PX-557 H

THE TECHNICAL MATERIEL CORP.
MAMARONECK, NEW YORK

SWITCH SHAFT

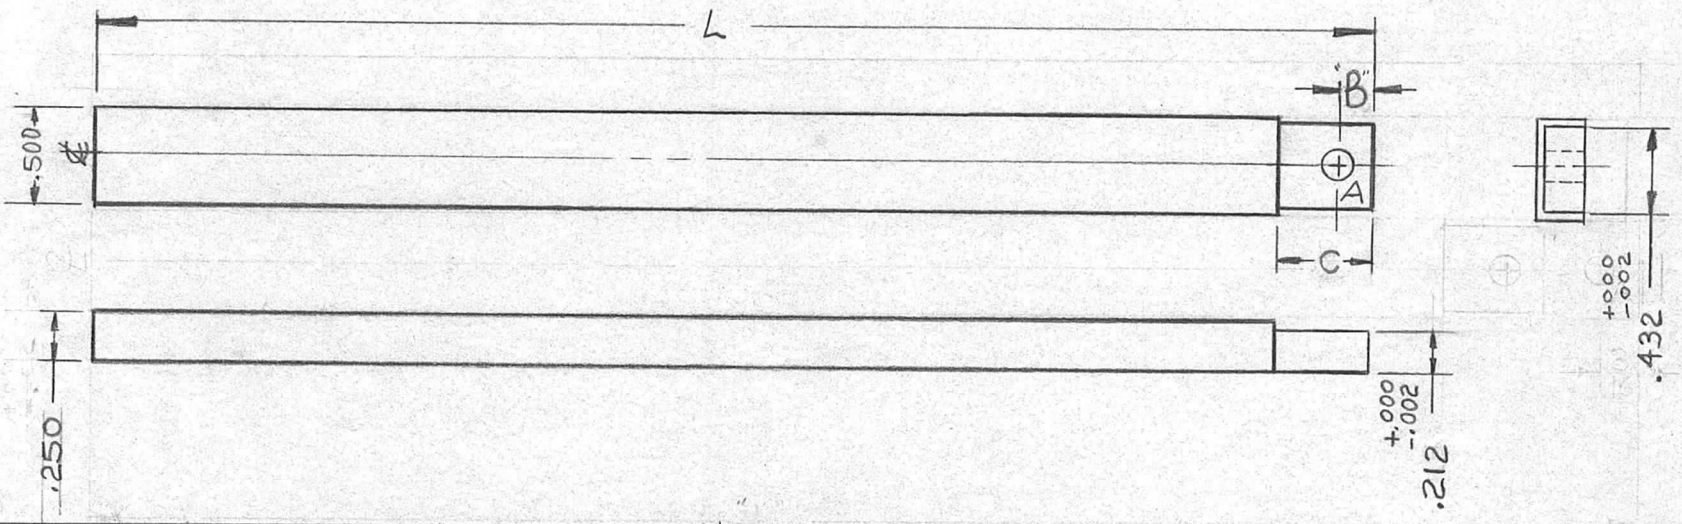
ISSUE	ITEM	CHANGED FROM	DATE	CH. NO.	DRAFTS	CHECKER	ENG. APP.
H	1	-2 "B" WAS 3/32 "C" WAS 5/16	11-30-65	15250	H.V.V	QCB	
G		CLERICAL CHANGE	8.24.64		JJB	@	
F	2 1	COLUMN "C" ADDED 9/16 DELETED	4.15.64	11233	JJB	[illegible]	T.K
E	1	Added PX-557-2	5/23/61	4947	DJM	QCB	[illegible]
D	3 2 1	9/16 DIM. WAS 1/2 .212 DIM. WAS .218 .432 DIM. WAS .437	3-2-61	4316	W.A.F.	QCB	
C	2 1	DIM "B" WAS 3/16" DIM 1 1/2 WAS 2 1/2" (Chart "L")	11/28/60	3599	DJM	QCB	
B	1	"L" DIM WAS 5" (PX-557-1)	11-16-60	3456	RU	[illegible]	
A	1	SHOULDER ADDED	9-13-60	~	R. Vizzo	[illegible]

TMC PART #	"L"	"B"	"C"	USED ON	AMOUNT REQ
PX-557-1	5 3/4	3/16	9/16	CHG-1	1
PX-557-2	1 1/2	1/8	9/32	CHG-1,2	1
PX-557-3	5 1/4	3/16	9/16	CHG-2	1
